RE: 200 Sydney Drive, Alamo County File #VR14-1021

Dear Supervisor Andersen:

<u>Proposed Plan is a 3-story structure and does not comply with the County Ordinance:</u>
This has been an issue in every meeting. We have been concerned because the original Plan showed the space under the house as only 4 feet high. This four-foot measure was inconsistent with other parts of the Plan.

Exhibit 1: Analysis by Milani & Associates shows space under the house is a story

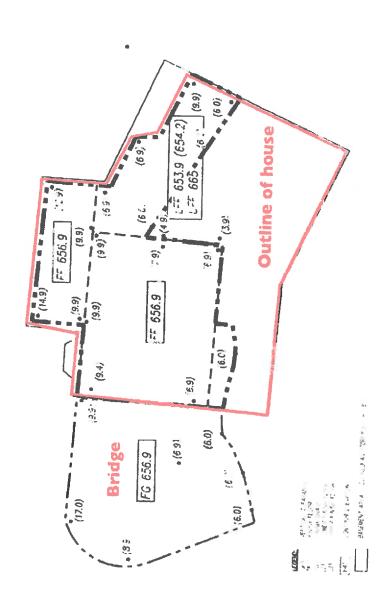
If it is more than 6 feet at any point, it shall be considered a story

• Majority of space is 6 feet or more

• Many "at any point" measures are up to 10 feet or more

Exhibit 2: The newest plans for this project (which were not included for the Planning Commission) clearly show this is a 3-story structure.

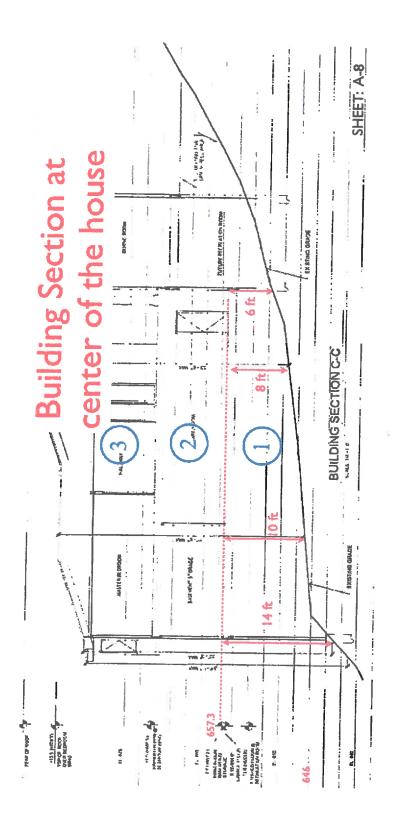
Zoning Ordinance: If it is 6 feet above grade at any point, it shall be a story
